## Annex A to Liaison reference #026.02

### Q.12/15 Comments on Liaison reference #015.03

#### Response to ITU-T Last Call Comments on the MPLS-TP Framework

Please find the IETF responses to the ITU-T Last Call comments on the MPLS-TP Framework received in the liaison “Comments on draft-ietf-mpls-tp-framework-10 [Ref #015.02]” of March 5, 2010.

Figure K: MPLS-TP edge-to-edge LSP transporting PW, Service-LSP and Ethernet VLAN transport service layer transport path signals

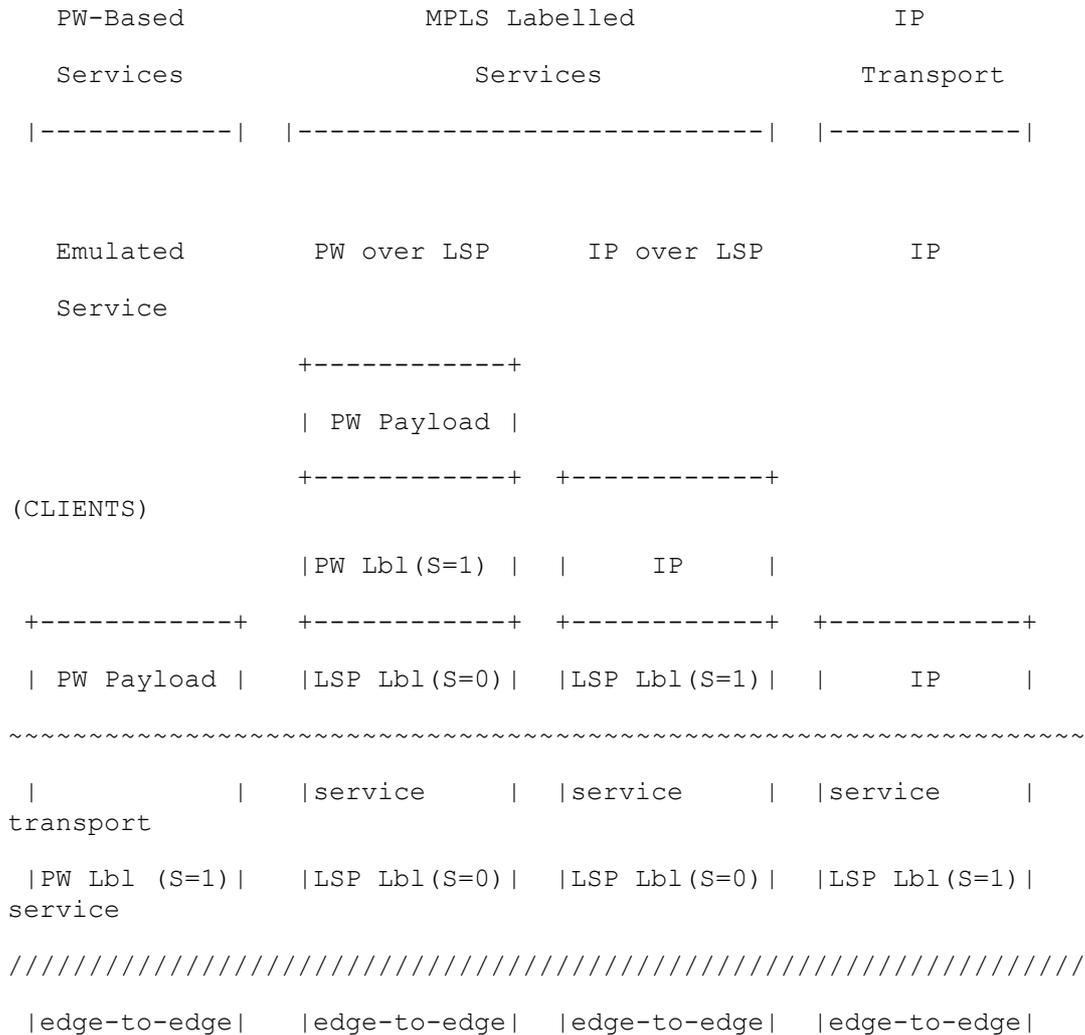
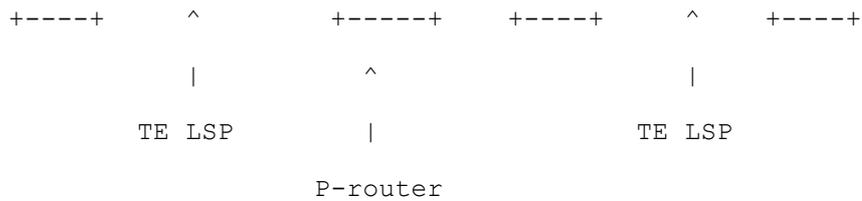
The 4th and 5th paragraphs of section 3.7 it is suggested that LSP, PW and section are for transport paths. In G.8110.1 we intend to map these against the three types of transport paths:

- transport service layer transport path
- transport path layer transport path
- section layer transport path.

This would result in the expansion of Figure 5 as shown below:

Please confirm an expansion of the figures from the draft into the figures shown above that will be included in G.8110.1 is acceptable.

Q.12/15 Response: We accept that this need not be added to the draft. Could you please confirm that the figure is correct and that you would have no objections if it were included in G.8110.1

We are concerned that this over specifies the MPLS label stack semantics. Experience in the development of MPLS demonstrates that such constraints on the MPLS protocol are not in the best interests of the network operator. This was discussed on a call with ITU-T SG15 experts and it was agreed that the figure should be not included. It should be noted that the architectural elements of the above figure are already covered in RFC3031 RFC3985 etc and further clarification is not needed.
